**Re: Responses to Information Requests  
Environmental Assessments - Prairie Creek Mine**

- **Phase II Mineral Exploration Drilling Program**  
(Land Use Application MV 2001C0022; MVEIRB File EA01-003)
- **Metallurgical Pilot Plant Program**  
(Water Licence Application MV2001L2-0003; MVEIRB File EA01-002)
- **Underground Decline and Exploration Drilling**  
(Land Use Application MV2001C0023; MVEIRB File EA01-002)

**Canadian Zinc Corporation Pilot Plant Environmental Assessment  
Response to Information Request**

PROJECT	PRAIRIE CREEK MINE		
TITLE	TAILINGS DAM REHABILITATION SECTION B - BERM ADDED		
PROJECT No.	0059-002-04	DWG. No.	08
REV.	C

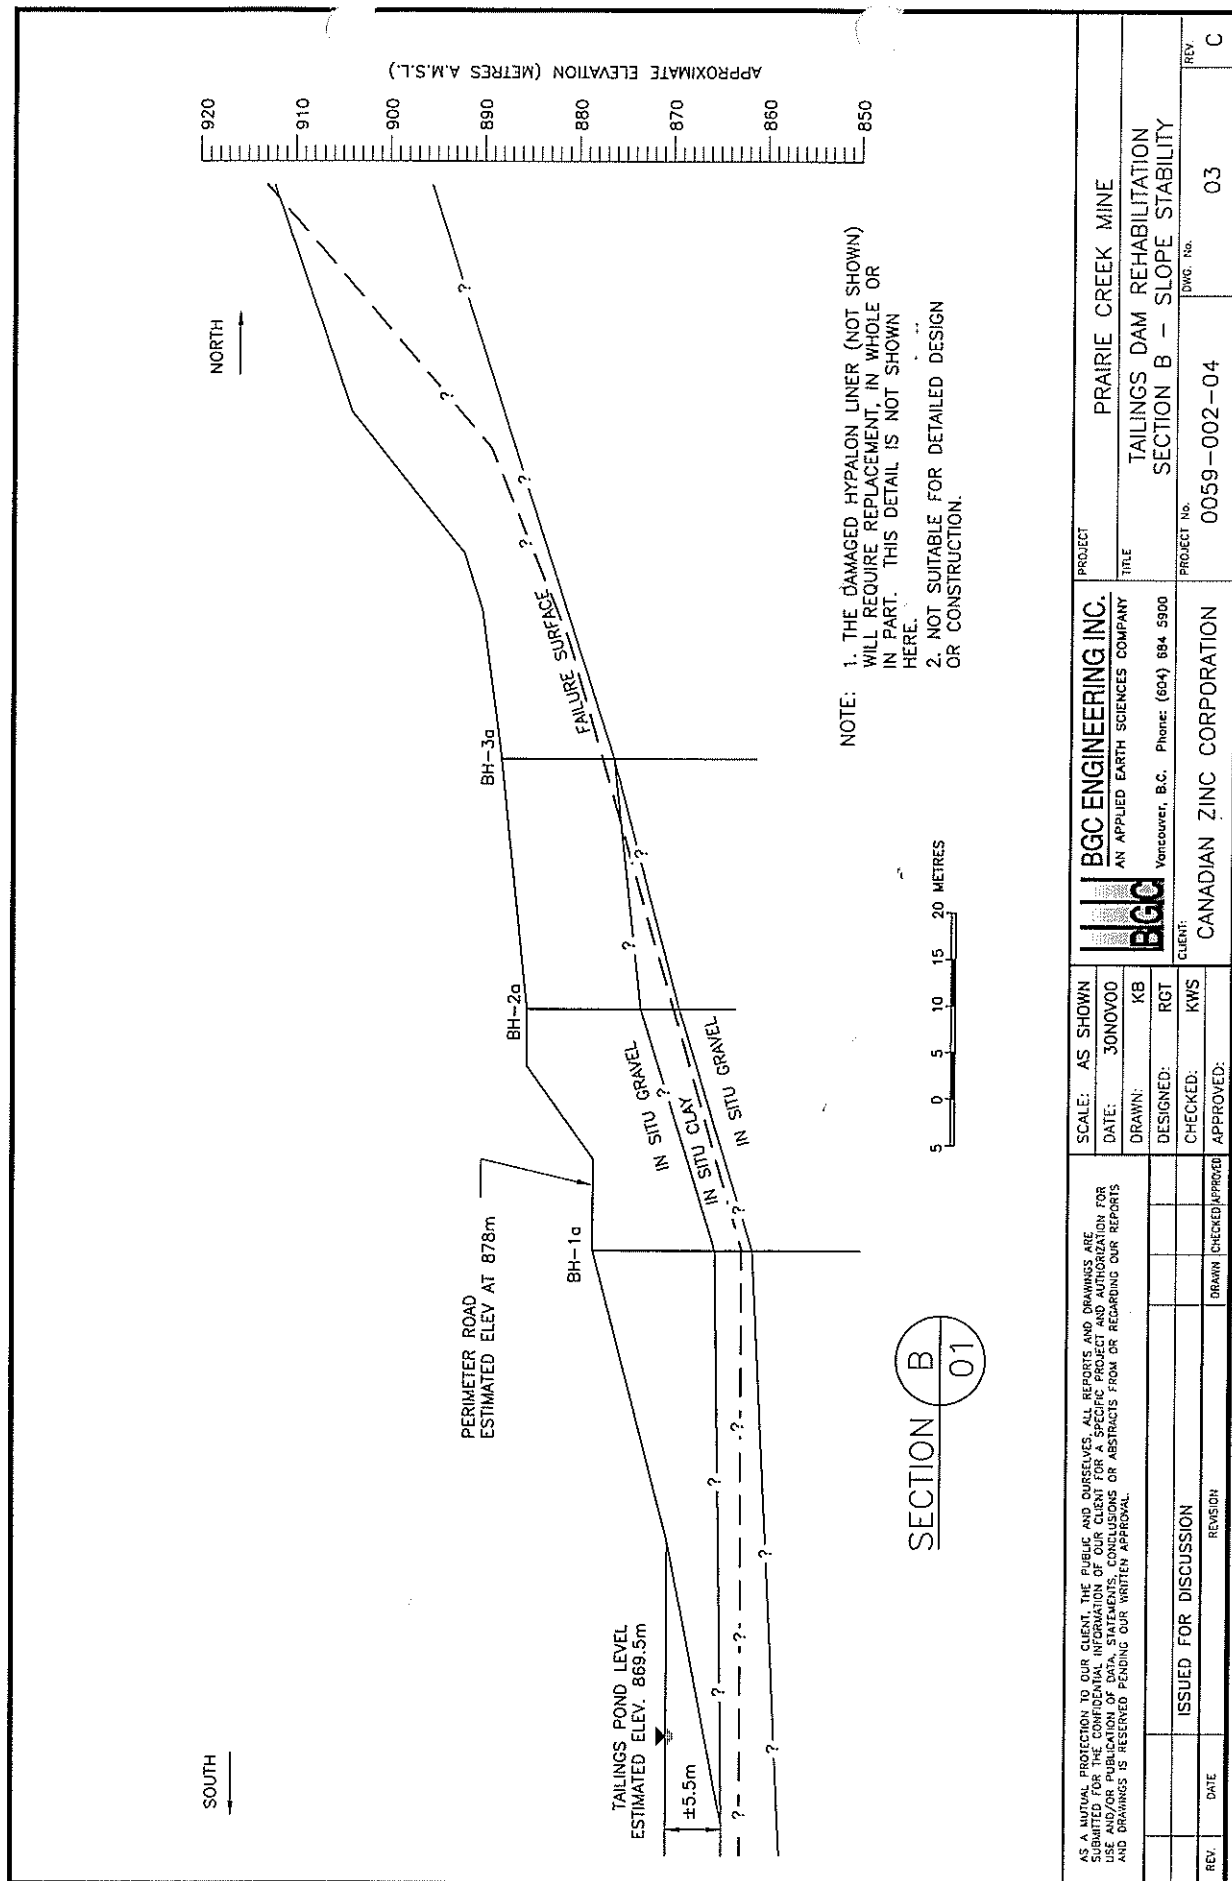
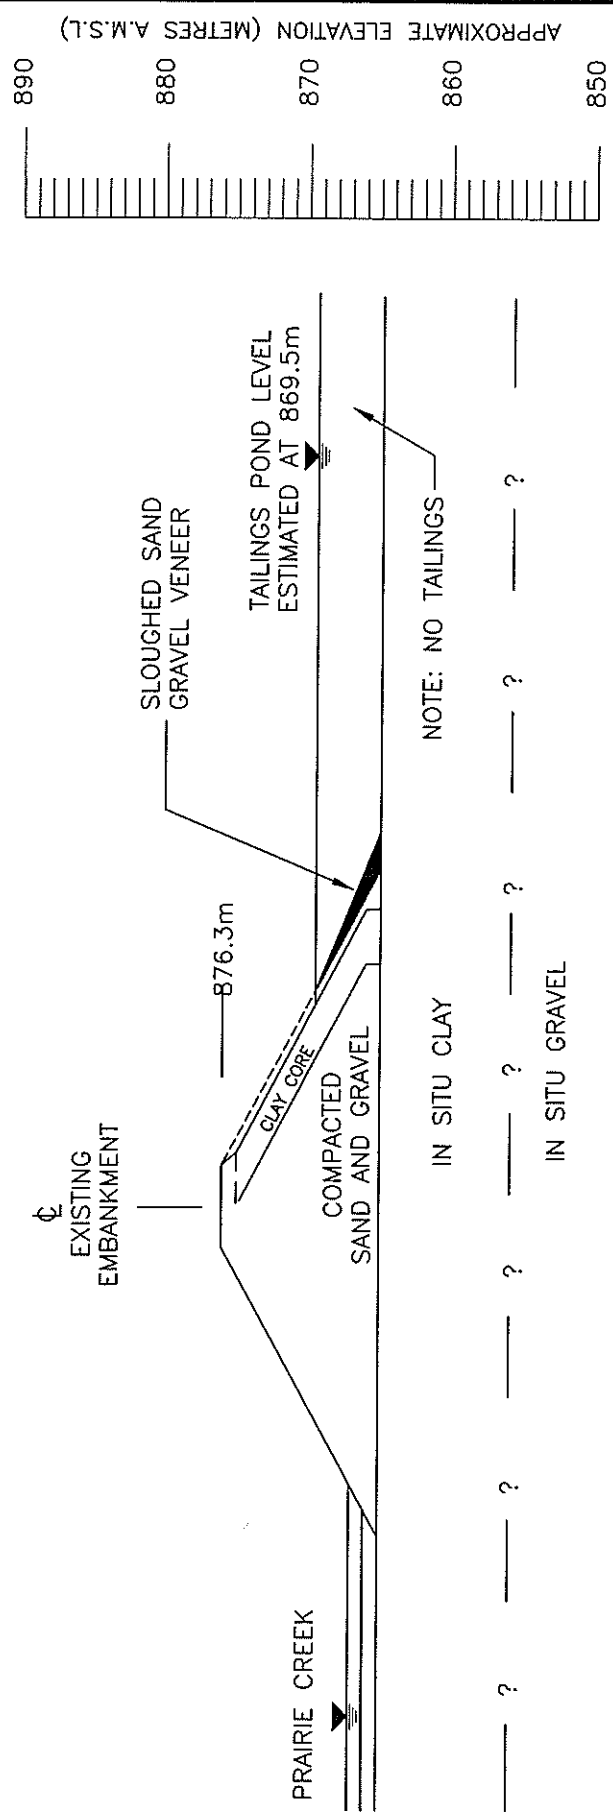
A considerable amount of sand and gravel is present at the upstream toe of the embankment as illustrated schematically in Drawing 02. Whether this needs to be added to, in whole or in part, before operations commence will depend upon how initial waste disposal operations are planned. The sequencing of sand and gravel cover replacement above the current pond elevation of approximately 869.5m, if necessary, should be considered during the next phase of study in conjunction with optimization of operational alternatives. Additionally, the thickness uniformity and integrity of the impervious clay core will also have to be investigated further during the next phase of study. For the time being, we recommend that Canadian Zinc allow for a \$150,000 up front cost to deal with these issues under the "most likely" scenario.
